## 21-COA-0202 1215 S. 3<sup>rd</sup> St.

Old Louisville Architectural Review Committee Public Hearing

> Bradley Fister, Historic Preservation Specialist September 22, 2021

### Request

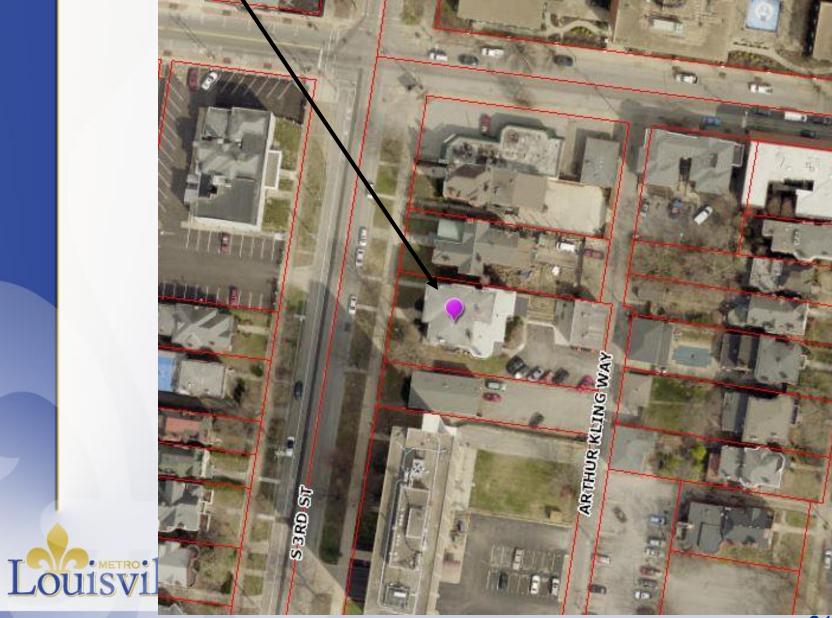
The applicant is seeking a Certificate of Appropriateness for after-the-fact approval for the construction of an 8' tall wooden privacy fence that runs from the corner of the carriage house south to the property line along the alley, then west to the rear side of the house, then north to connect to the house. The fence is minimally visible from the street. The existing parking lot in the rear of the house will be entirely removed. All of the asphalt will be removed and the yard regraded and planted with grass in the center and shrubs and flower beds along its perimeter.

The proposed location of the fencing is primarily along the rear and side property line of the building that faces S. 3rd St. The proposed fencing generally does meet the Old Louisville Design Guidelines for Site. The primary conflict with the Design Guideline is the height being greater than 7' as stated in ST-15.

1. The applicant shall lower the height of the fence to be less than 7'.
